# Cuan Na Loinge Road Protection Scheme

Stage 1 Road Safety Audit

Langan Consulting Engineers

**Figure 2.1 – Pedestrians Stepping into Road Space Where the Pavement Narrows**

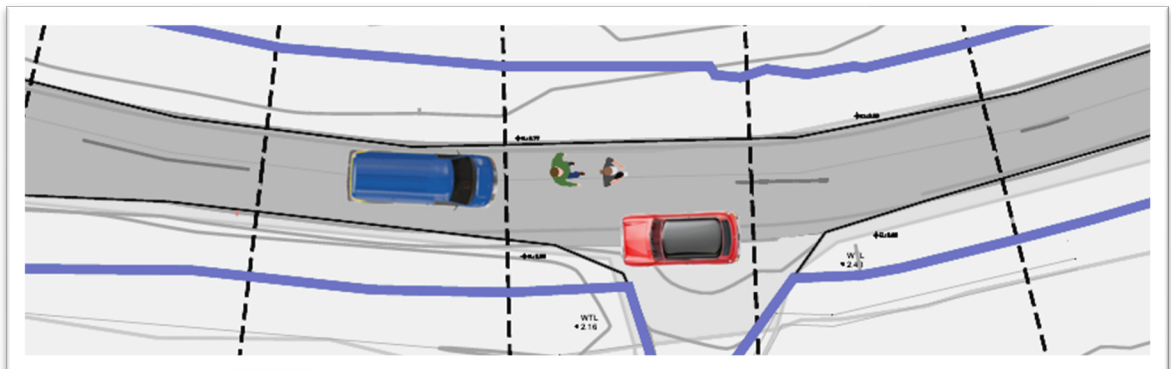
### 2.1 Problem: Space for Pedestrians to Take Refuge from Vehicles

The varying widths of road pavement, flood protection walls, and verge space pose risks to pedestrians who might unexpectedly step in front of approaching vehicles.

An appropriate horizontal alignment should be established for the road to offer a continuous and consistent pedestrian refuge area, allowing walkers to step aside safely when vehicles approach.
